314 S. Alcaniz Street

### New Construction

**Action taken: Conceptual Approval with comments.**

Scott Holland is seeking *CONCEPTUAL* approval for a new two-story, single-family residence. The demolition of the existing non-contributing structure was approved in December 2019 and a Variance to reduce the required rear yard setback was denied in February 2020. Since then, the applicant has revised the site plan to accommodate the zoning setback requirements.

SITE PLAN - EXISTING CONDITIONS / DEMOLITION  
SCALE: 1/4"=1'-0"

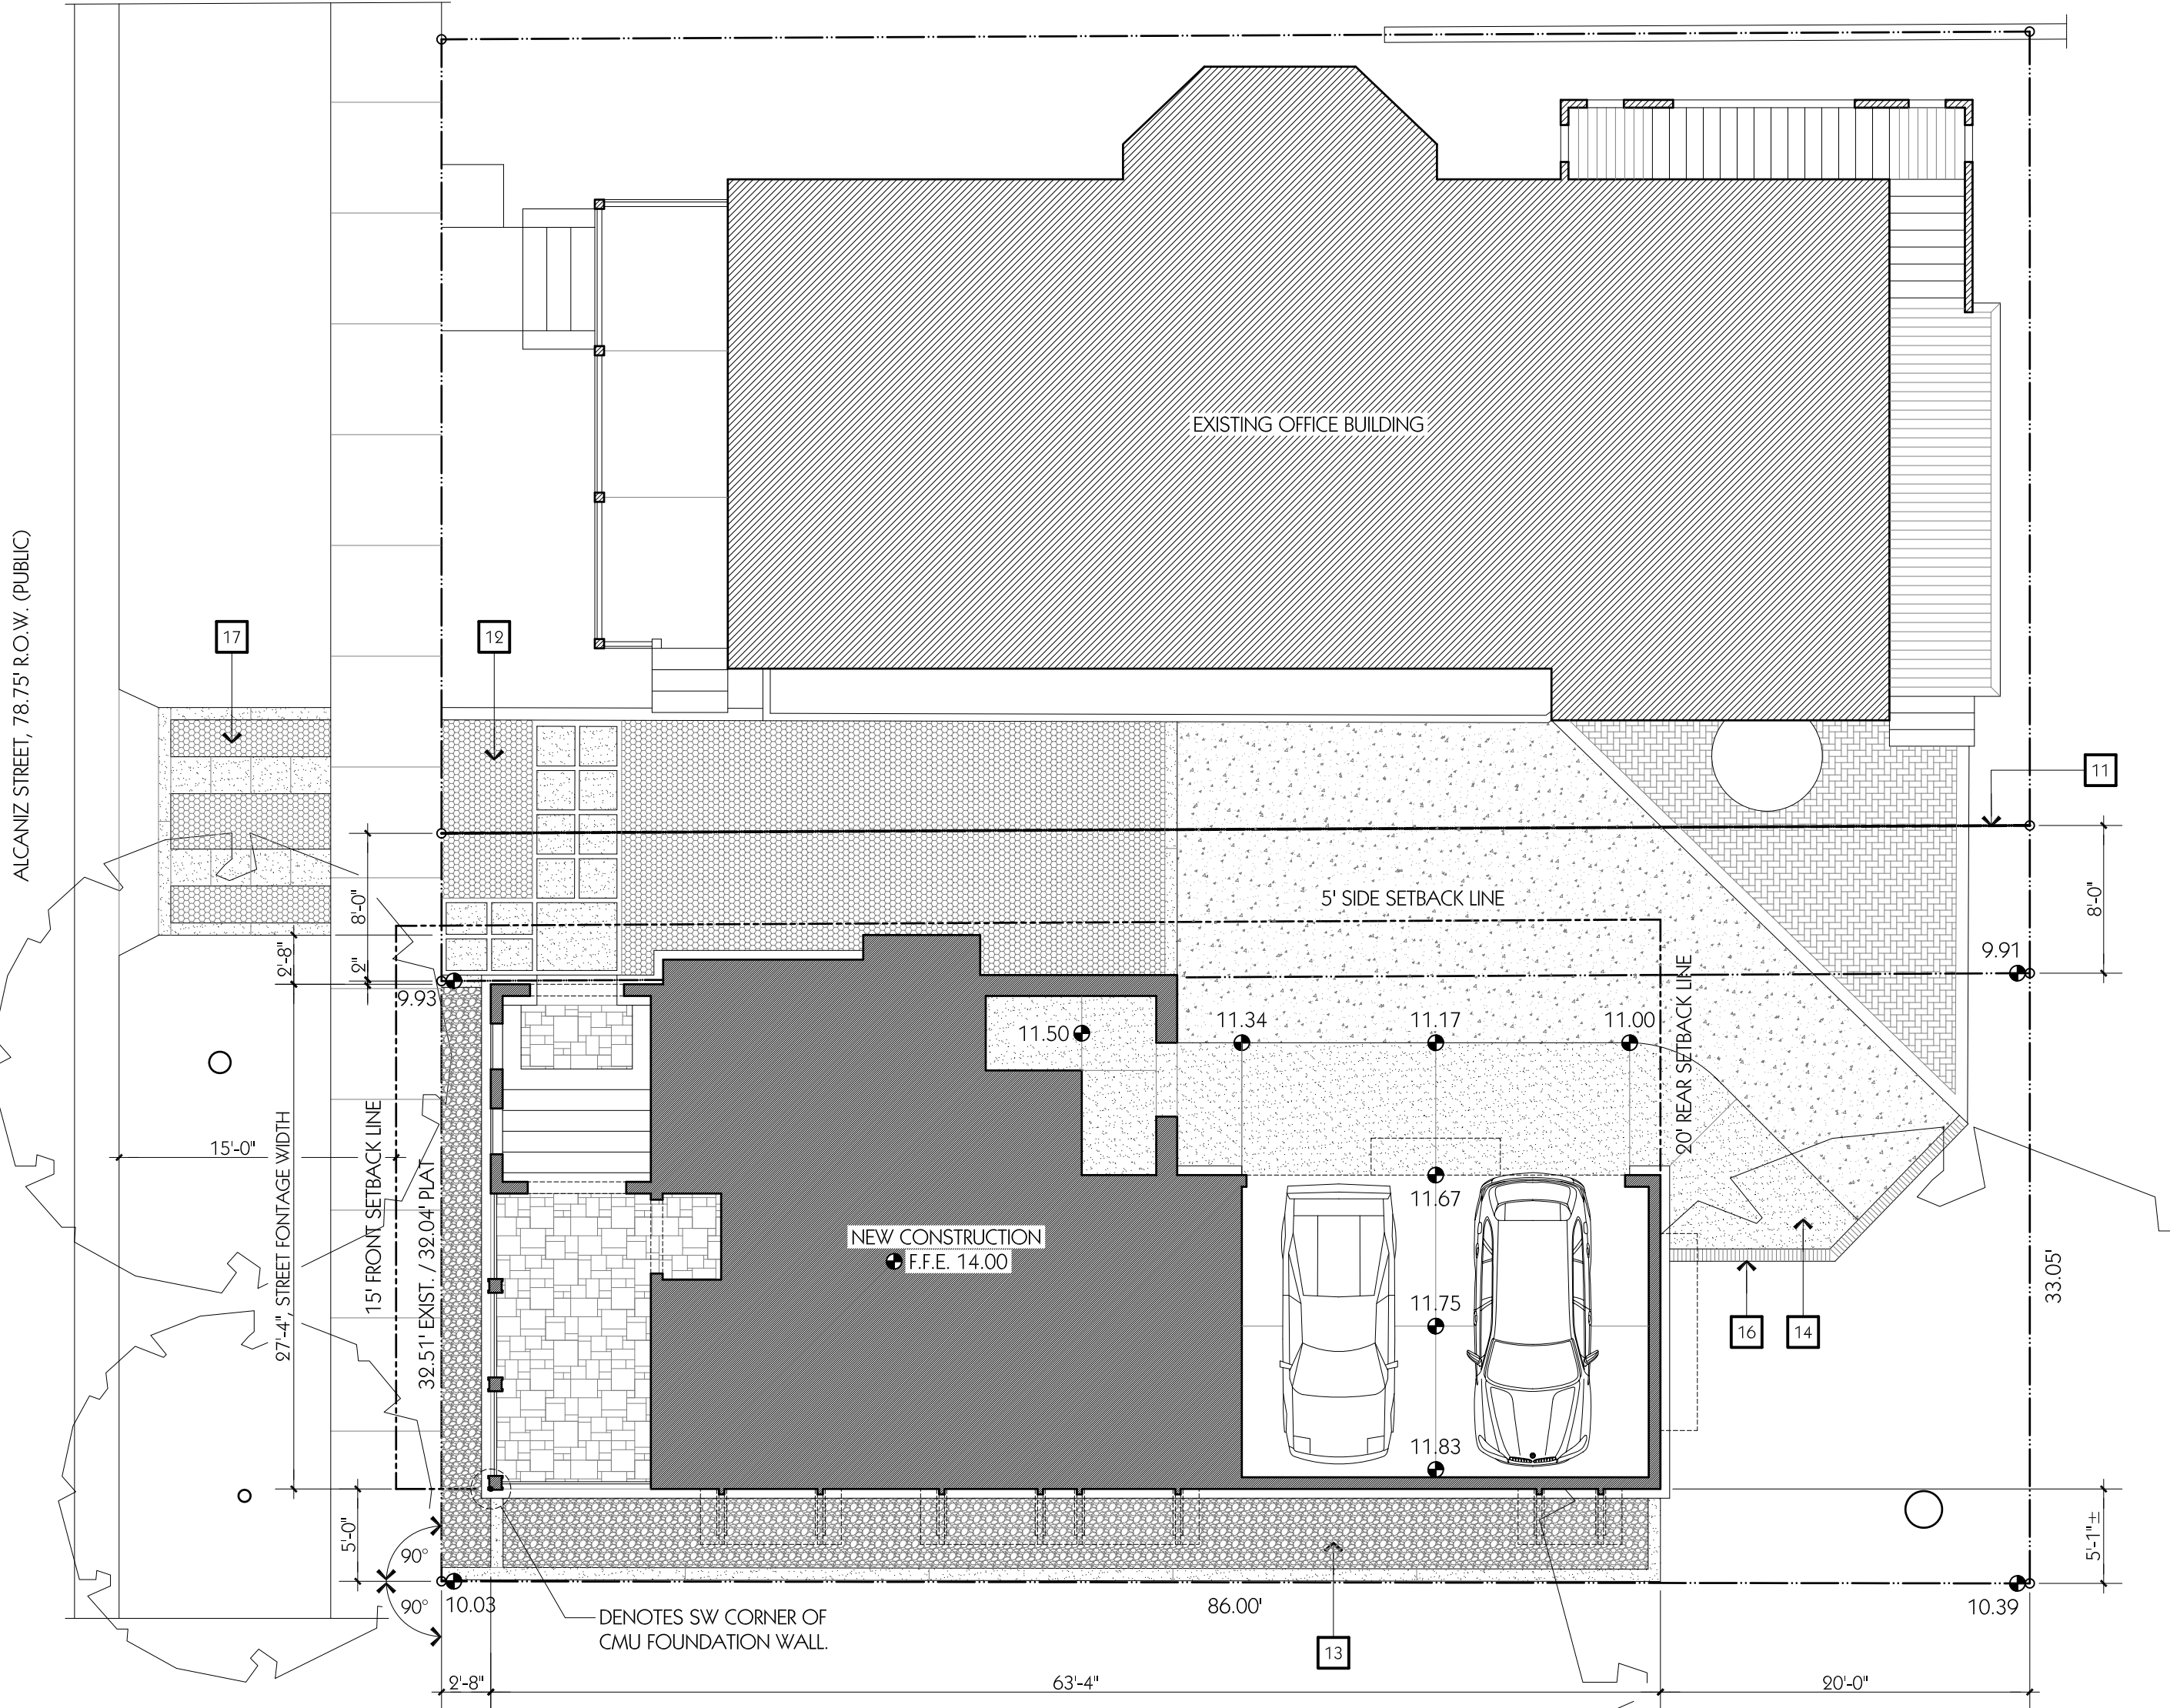
Mr. Holland addressed the Board and stated without the Variance, the footage of the house increased to 2,042 sq. ft. He had gotten permission to remove the tree at the rear, but he would be replanting oak trees in the area between the property line and the edge of the road. Board Member Mead asked about the west elevation louvers, and Mr. Holland indicated his desire was to make the louvers operable. Mr. Mead's concern was when the shutters were open that they fit within the frame of the façade, and Mr. Holland agreed this was a viable comment. Board Member Salter pointed out the bronze metal railing was not typical with the district, and Board Member Campbell-Halter felt the bronze was more traditional and liked the converging of the two timeframes. Mr. Holland indicated the columns would be either be mahogany or Spanish cedar; since he was trying to meet a 200mph wind load he would be using a steel or structural aluminum core. Staff explained the Streetscape Type 2 features in the LDC, Figure 12-2.1 for the Wood Cottages District. Regarding the extensions on the north and east elevations, Mr. Holland stated he would probably change that from stucco to wood. Chairperson Quina advised the railing type for this district is typically wood. Board Member Salter stated if the bronze material becomes part of the architecture that spreads throughout the house and some of the other detailing, that concept would probably work.

**Board Member Salter made a motion to approve with the comments noted in discussion for material consideration, seconded by Board Member Campbell-Hatler, and it carried unanimously.**
